TRUCK, TRANSPORTER, FLOATING BRIDGE, MC3, W/WINCH, MACK, LAUNCH AND RECOVERY VEHICLE (LRV)

REPLACEMENT OF BLACKOUT BRACKET ON FRONT LIFT FRAME

MODIFICATION INSTRUCTION

Figure 1 – Replacement Bracket, Blackout Headlamp Mounting

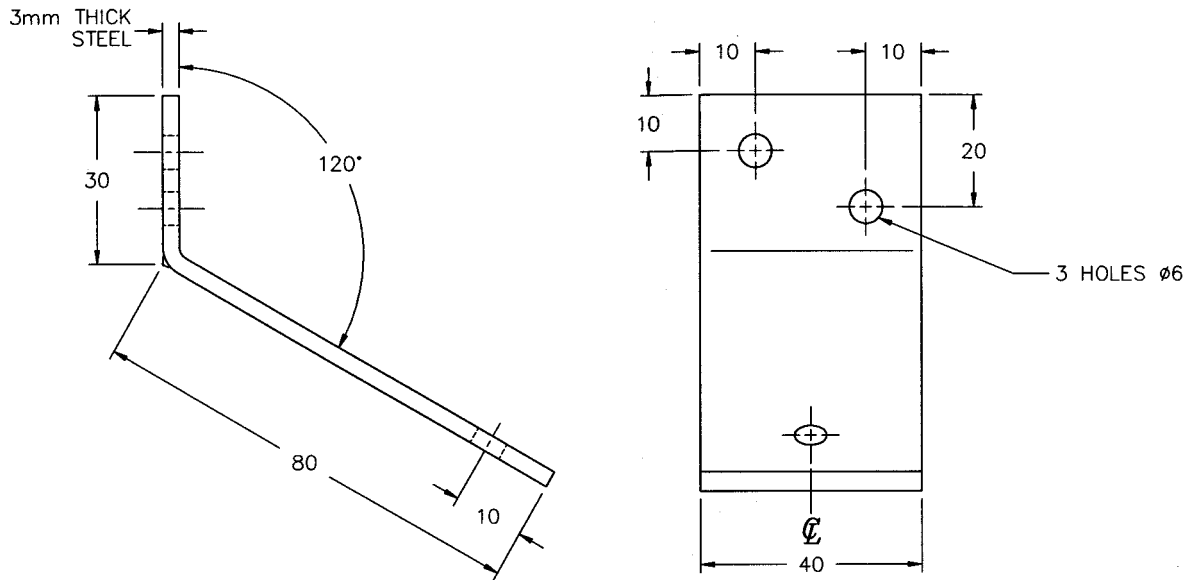
1. This instruction details the replacement of the blackout headlamp bracket on the front lift frame of the Launch and Recovery Vehicle, NSN 2320-66-131-6653, to prevent modules catching on the bracket during launch and recovery of Floating Support Bridge modules.

- a. Prefabricate the replacement bracket as shown in Figure 1 from the steel detailed as Item 1 in Table 1.
- b. Remove the blackout headlamp from the existing bracket.
- c. Remove the existing bracket and install the replacement bracket, as shown in Figures 2 and 3.
- d. Refurbish the frame, ensuring all burrs are removed and then repaint the area.
- e. Attach the blackout headlamp as it was mounted on the existing bracket with mounting bolt uppermost.
